RE: Site Plan Revisions - Tyndale Green Zoning By-Law and Official Plan Amendment Application

ASI File: 20CH-201

Memorandum

Figure 1: Original Site Plan (June 2021)

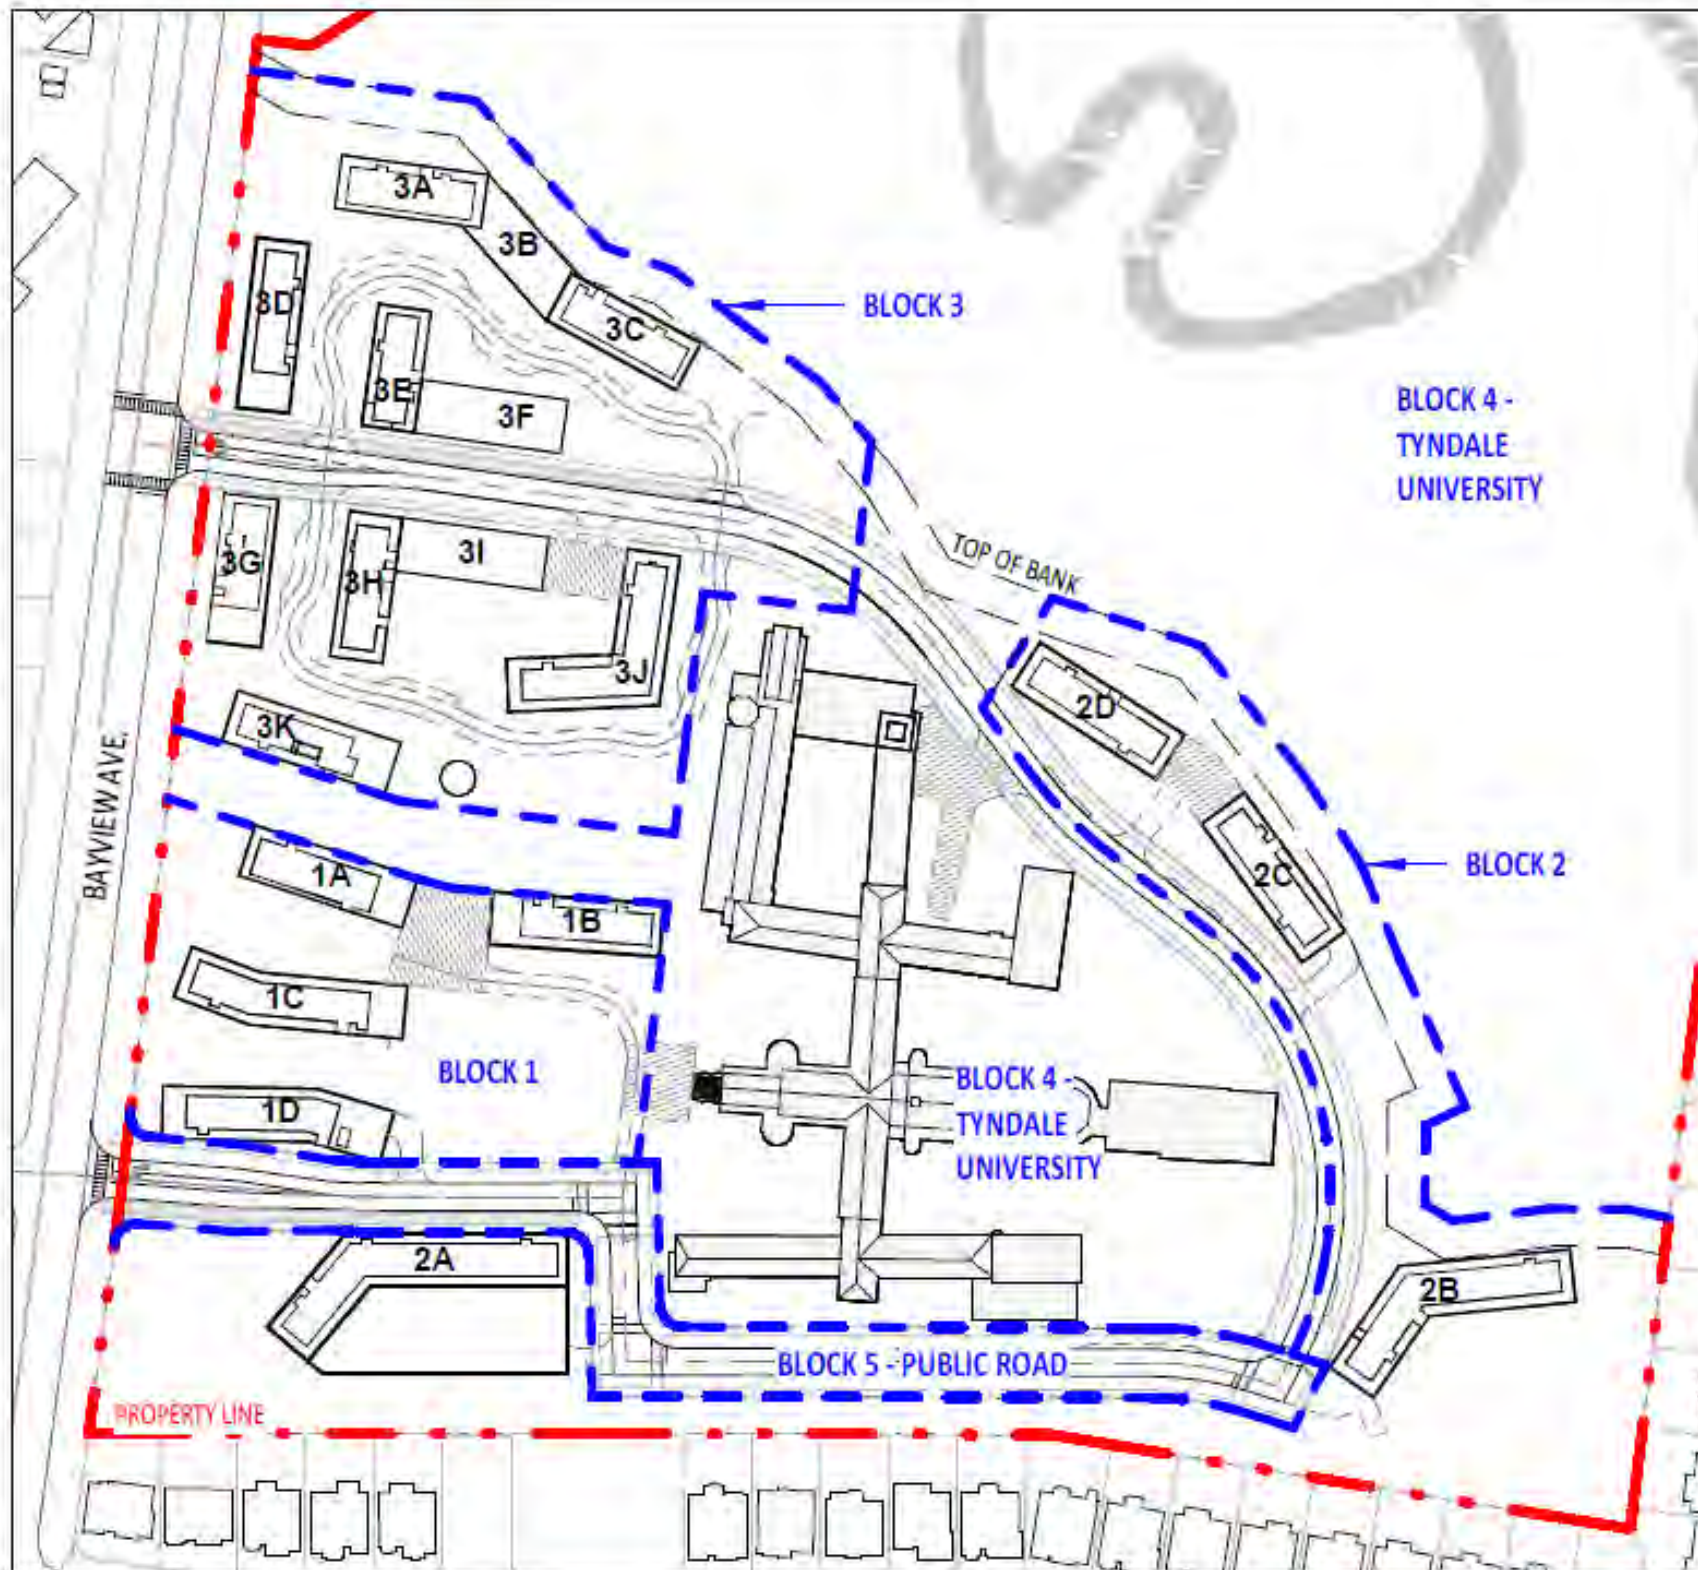
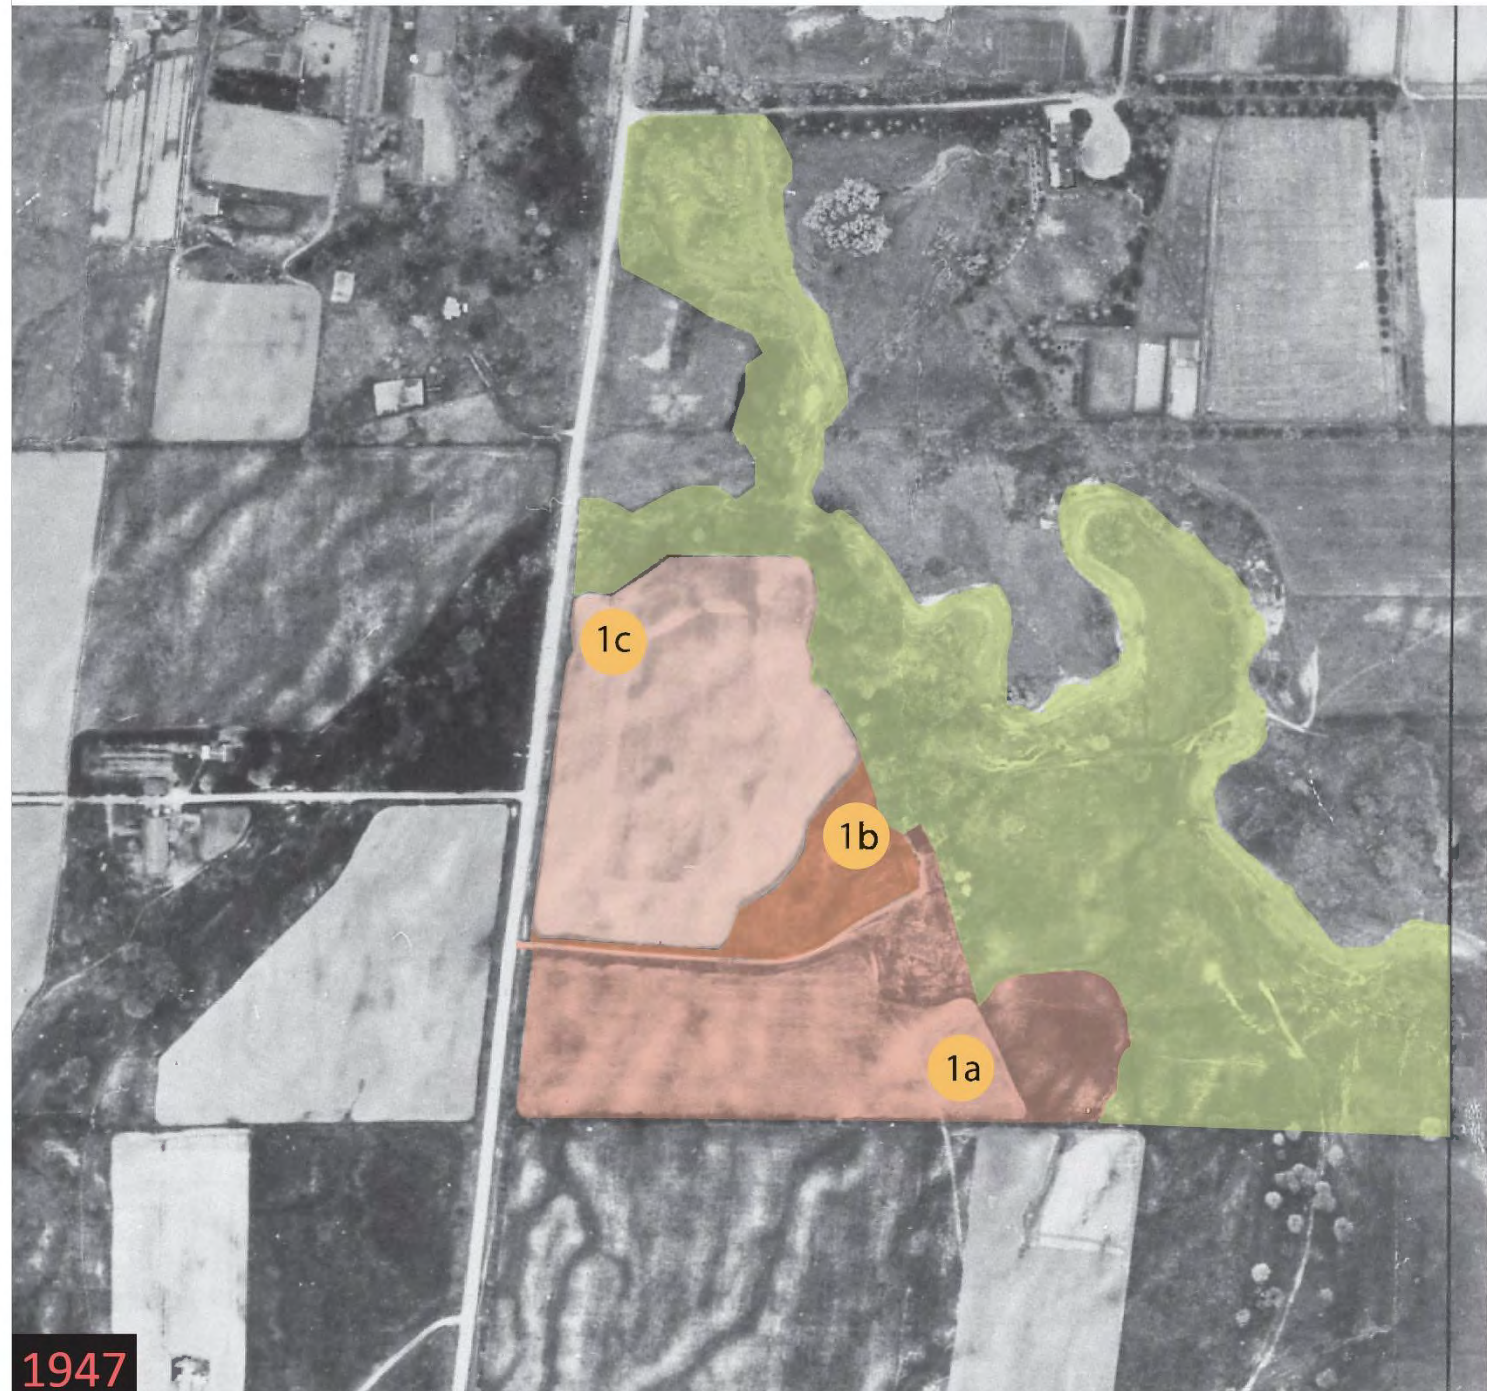
- Staff appreciate the identification and conservation of significant views. Please remove building 1A, which blocks significant views toward the Motherhouse from the original driveway. These views have been identified as significant in the Heritage Impact Assessment and by Heritage Planning research staff. In addition, please revise the massing and/or location of buildings 2B and 2C. As proposed, these buildings will negatively impact the view from the ravine toward the chapel, which has been identified as significant by Heritage Planning research staff.

In November 2022, the City of Toronto circulated suggested refinements (Without Prejudice) to updated plans as presented by the applicant, including the following recommended revisions addressing outstanding comments relating to cultural heritage considerations:

- Remove Building 1A;
- Reinterpret elements of original cultural landscape particularly pedestrian circulation patterns as it relates to the original gate, rotunda building, central lawn and port-cochere;
- Increase building 1D setback and articulate to open up views to motherhouse from park and Bayview; and
- Relocate vehicular drop-off between buildings 2B and 2C, and increase setback between buildings to reveal profile of motherhouse from natural landscape.

- Removal of Building 1A;
- Increase Building 1D setback;
- Increase in size and regularization of shape of the parkland dedication area in the central portion of the site (the northerly of the two proposed), from 4040.63 m² to 4523 m²; and
- Increased setback between buildings 2B and 2C to enhance visual relationships and connections between the core of the Motherhouse and the ravine located on the east side of the site.

Figure 1 to Figure 3 show refinements to the site plan for the application, including the latest iteration. The current site plan demonstrates a comprehensive conservation strategy for the Tyndale University campus landscape. These changes result in the following key positive net effects and demonstrate consistency with Conservation Design Parameters developed for the site (ERA 2023):

- Removal of Building 1A positively impacts conservation objectives for the site. This strategy successfully maintains original landscape composition characteristics of the site through retention of the three primary forecourt spaces framing primary entrances to the building complex on its southern and western elevations (See Tyndale Campus Landscapes – Motherhouse Forecourts (6) and Secondary School/Annex Forecourt (7); ERA 2023:6).

- Refinement to the setbacks between Buildings 2B and 2C will improve visibility of the Motherhouse chapel and the building's eastern elevation from the ravine area.
